May 25, 2004

Subject: Oconee Nuclear Station  
Docket Numbers 50-269, 270 and 287  
License Amendment Request associated with the  
Application of Leak-Before-Break for Unit 3  
Passive Low Pressure Injection Cross Connect  
Modification, TSC Number 2004-04

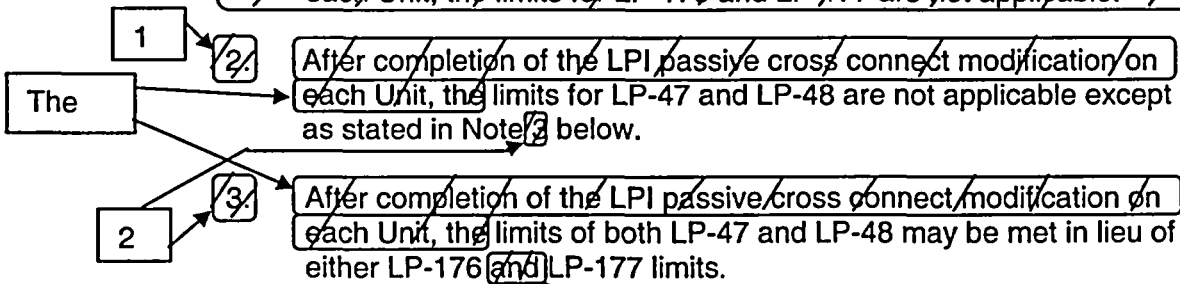
1. ~~Prior to completion of the LPI passive cross connect modification on each Unit, the limits for LP-176 and LP-177 are not applicable.~~

LCO 3.4.14, Note 1, which states that the limits of LP-176 and LP-177 are not applicable prior to completion of the LPI cross connect modification, is no longer required since the modification will be complete on all three units and is deleted. The subsequent Notes are renumbered accordingly.

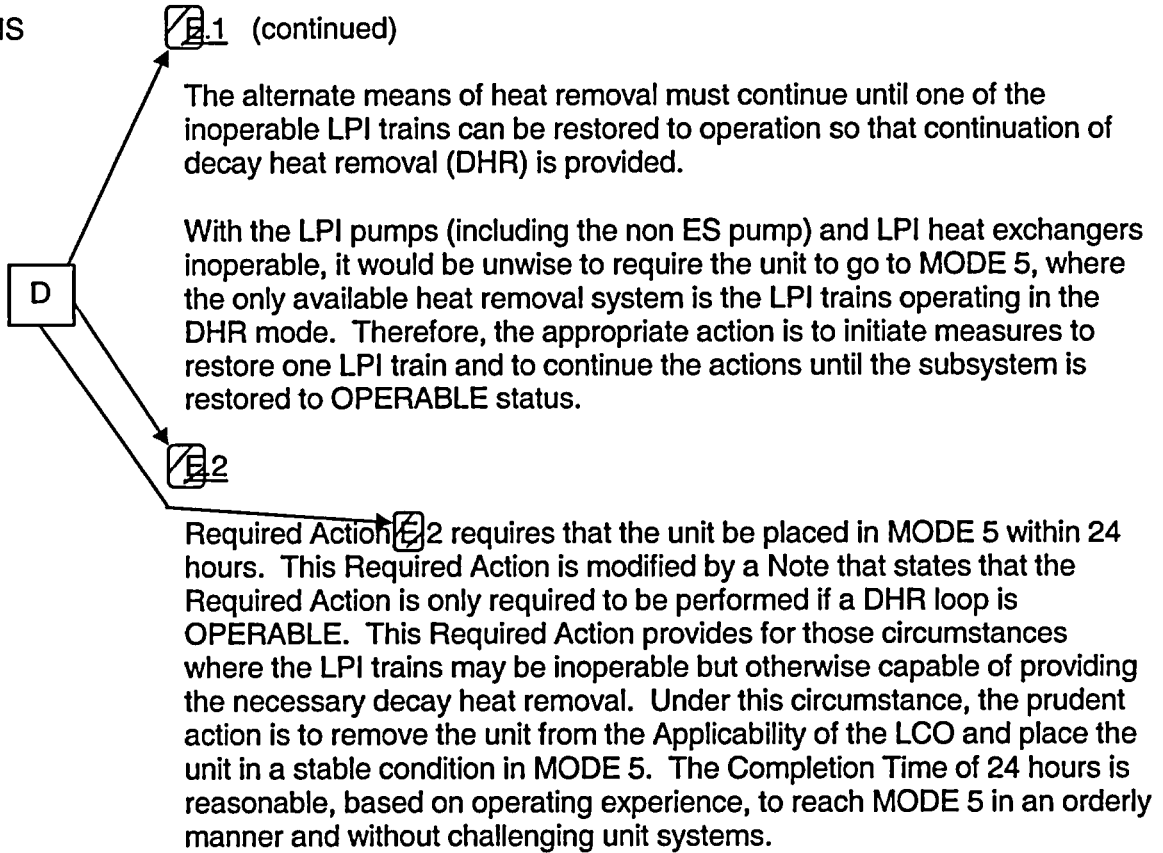
If the Required Action and associated Completion Time of Condition A B or C are not met, the unit must be brought to a MODE in which the LCO does not apply. To achieve this status, the unit must be brought to at least MODE 3 within 12 hours and MODE 4 within 60 hours. The allowed Completion Times are reasonable, based on operating experience, reach the required unit conditions from full power conditions in an orderly manner and without challenging unit systems.

The Action Table is revised to delete Action B and re-letter subsequent Actions. Action B is no longer applicable since the LPI cross connect modification will be complete on all three Oconee Units after the Unit 3 Fall 2004 Outage. The new Condition B is revised to delete the word "required" since this modifier is no longer needed with the completion of the LPI cross connect modification on all three Units.

**Figure 1**  
**Passive LPI Cross Connect Modification**

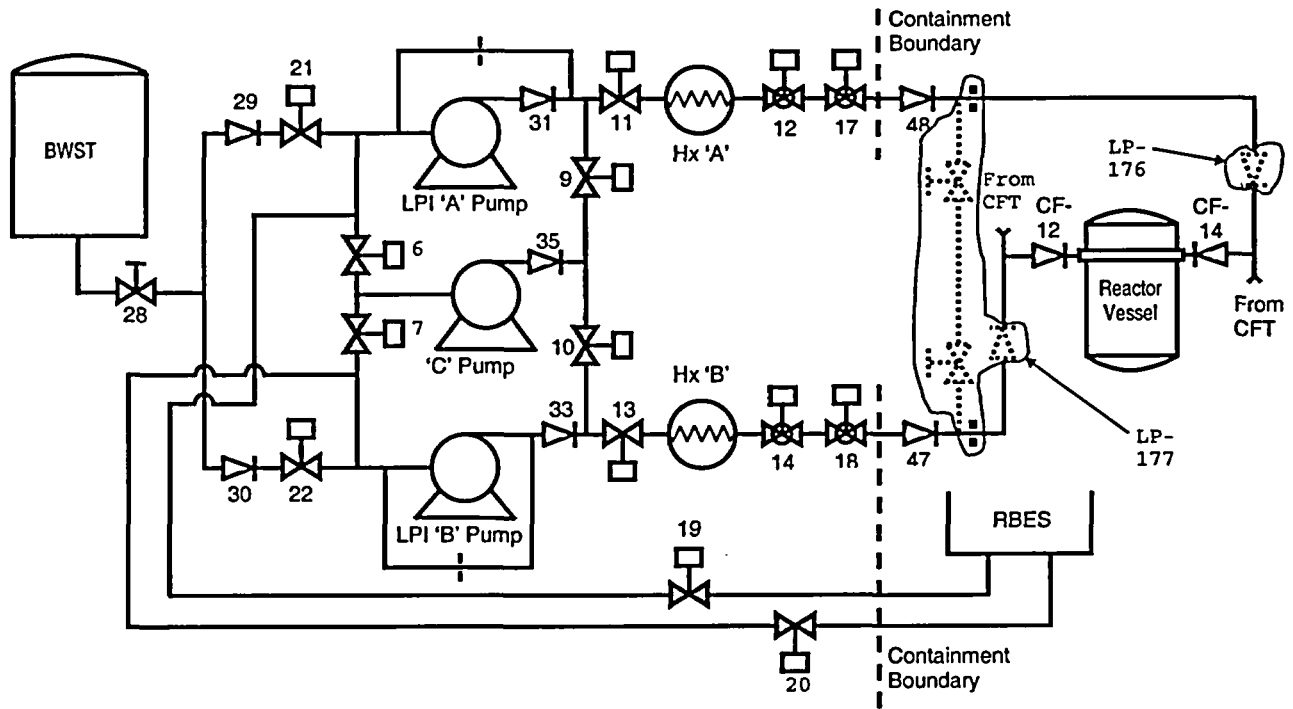
This modification will cross connect the LPI trains at a location inside containment downstream of check valves LP-47 and LP-48 (See Figure 1). It also adds new check valves (LP-176 and LP-177) downstream of the cross connect piping to prevent the blowdown of both Core Flood Tanks (CFTs) out a CFLB. Flow restricting devices will be designed and installed to limit LPI flow under low back-pressure conditions for LPI pump Net Positive Suction Head available (NPSHa) concerns and also to divert sufficient flow to the intact header during a postulated Core Flood Line Break (CFLB). These devices are also sized to ensure sufficient flow in the event of a Large Break Loss of Coolant Accident (LBLOCA) as well as sufficient cool down capacity during a unit shutdown.

Selected portions of the CF and LPI/DHR piping design were reviewed against the limiting criteria specified in 10 CFR 50 General Design Criterion 4 (GDC-4), SRP 3.6.3 and NUREG 1061 to determine if LBB technology could be used as a basis for excluding the dynamic effects associated with a high energy pipe rupture. The selected portion of piping is the 14 inch CF line connecting the CF tanks to CF-12 and CF-14 and the 10 inch LPI/DHR line downstream of the new check valves 3LP-176 and 3LP-177 to be installed as part of the LPI Cross Connect Modification. See Figure 1.
